P-9681-1
S2438
17687

SYMBOL OF QUALITY AN ISO 9001 COMPANY	<b>JINDAL ALUMINIUM LTD.</b> BANGALORE-560073 (INDIA)	NAME	DATE
		DRAWN	J.P.KAUSHIK 27-03-2010
		CHECKED	
		APPROVED	J.N. RAI 09-04-2010
1. ALL DIMENSIONS ARE IN mm. 2. ROUND OFF ALL SHARP CORNERS WITH 0.4 mm. 3. TOLERANCES WILL BE AS PER IS:3965-1981 UNLESS OTHERWISE SPECIFIED		SCALE	5:1
		AREA mm <sup>2</sup>	82.563
		PERIMETER mm.	92.627
PARTY'S NAME		PRECISION REEDS MFG. CO., MUMBAI	WEIGHT kg/m
PARTY'S DRAWING No.		AS PER DRAWING	0.223
ALLOY & TEMPER		HE9 WP	DRAWING No.
DESCRIPTION		CHANNEL- TEXTILE SECTION	SECTION No.
		P-9681-1	-
		S2438	S2438(ISSUE-4)
		17687	17687

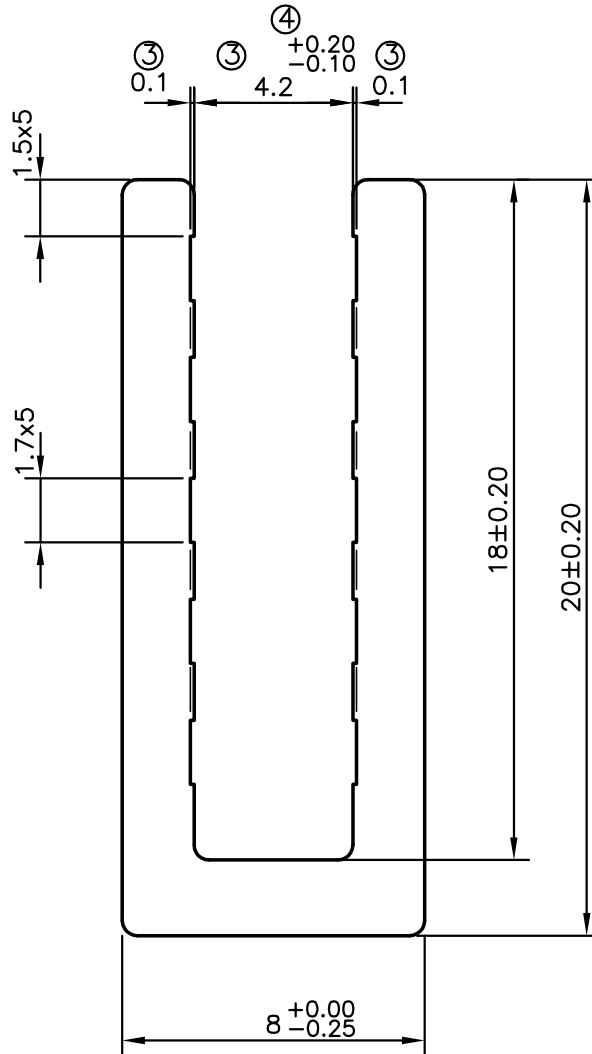
DIMENSIONS CHANGED 4.40 mm TO 4.0 mm AND GROOVE ADDED  
 WEIGHT ALSO CHANGED FROM 0.218 kg/m TO 0.228 kg/m

DIMENSIONS CHANGED 4.0 mm TO 4.2 mm AND GROOVE DEPTH CHANGED  
 FROM 0.2 TO 0.1 WEIGHT ALSO CHANGED FROM 0.228 kg/m TO 0.223 kg/m

TOLERANCE CHANGED FROM 4.2<sup>+0.10/-0.20</sup> TO 4.2<sup>+0.20/-0.10</sup>
